**CITY OF SNELLVILLE
DEPARTMENT OF PLANNING & DEVELOPMENT
MAYOR AND COUNCIL**

CASE NUMBER: RZ 20-01 CUP 20-01

REQUEST: Rezoning, Conditional Use Permit, Request for Variances

DEVELOPMENT/PROJECT: Floral Shop & Auto Service and Repair Shop

The proposed site plan, submitted by the applicant.

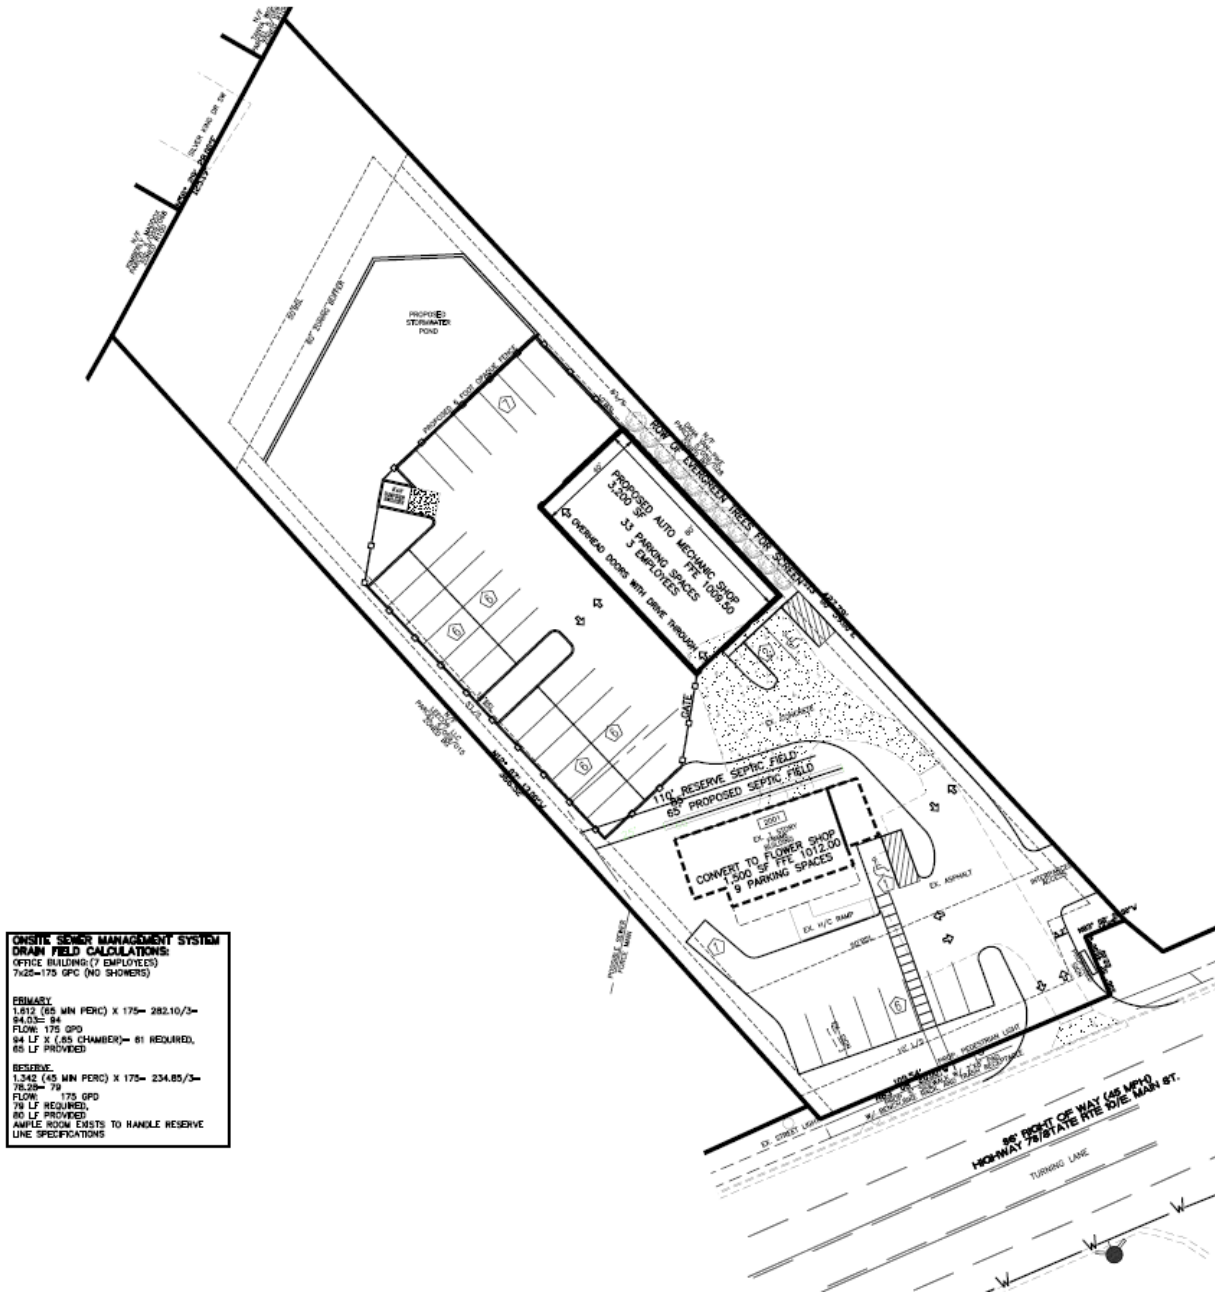
The existing structure is located in the southern portion of the property, and is setback approximately seventy-eight (78) feet from the US-78 / E. Main Street right-of-way. Improvements to the existing parking area include seven (7) parking spaces and one (1) handicap parking space located in front of the existing building.

The rezoning site plan shows a proposed five (5) foot wide sidewalk with small amenity pad for a pedestrian bench, trash receptacle and bicycle rack. One pedestrian light is shown adjacent to the amenity pad. Pedestrian connectivity between the sidewalk and entrance to the existing building is provided by a five (5) foot wide hatched walkway in the parking lot with a concrete walkway connection from the parking lot curb to the sidewalk. Although the applicant is proposing construction of a five (5) foot wide sidewalk along the right-of-way, in 2010 the adjacent property to the west (Future Services) was required to install a six (6) foot wide sidewalk per the City Code, so continuation of the six (6) foot wide sidewalk for this project will also be required (see Condition #7).

Although no monument sign drawings have been provided by the applicant, there is a proposed sign shown just east of the full-access drive. The final sign location may vary in order to comply with the sign ordinance requirements for sign type, sign area, sign height, and sign setback from the right-of-way.

An inter-parcel access stub is shown just to the east of the full-access drive that could provide future connectivity to the adjacent Family Tree Nursery property should they choose to make the final connection.

There is a two-way driveway that provides vehicle access to a 3,200 sq. ft. proposed auto mechanic shop and related parking. Two (2) parking spaces are shown in front of the proposed building with the majority of the parking to the side and rear of the proposed building. There are seven (7) spaces in the rear of the building and twenty-four (24) spaces along the side

The site plan shows sixty-five (65) feet of proposed septic system drain field with an additional one-hundred-ten (110) feet of reserve strip for future septic use. The nearest sanitary sewer manhole is located to the west approximately four-hundred-twenty-five (425) feet from the property line, well outside the threshold requiring connection to sanitary sewer.

One dumpster pad and enclosure is shown in the northwest corner of the mechanic shop parking lot. Although there is no dumpster pad and enclosure shown for the existing building, one shall be required to serve the future flower shop or other tenant use (see Condition #2). The code requires these enclosures to be eight (8) feet in height and made of brick, stucco, or split-face block.

Although no detail has been provided nor shown on the colored rendering, there is a proposed six (6) foot high opaque fence with gate will enclose the main parking area of the auto mechanic shop for security and screening of vehicles that are parked or stored outside.

There is a proposed stormwater detention pond located behind the auto mechanic parking area which includes a concrete retaining wall.

There is a sixty (60) foot undisturbed buffer shown that separates the proposed commercial use from the two residential lots of the Saddle Club Estates subdivision. Combined with the stormwater detention pond location, the proposed auto mechanic shop is approximately one-hundred-sixty-two (162) feet from the rear property line and the Saddle Club Estates subdivision.
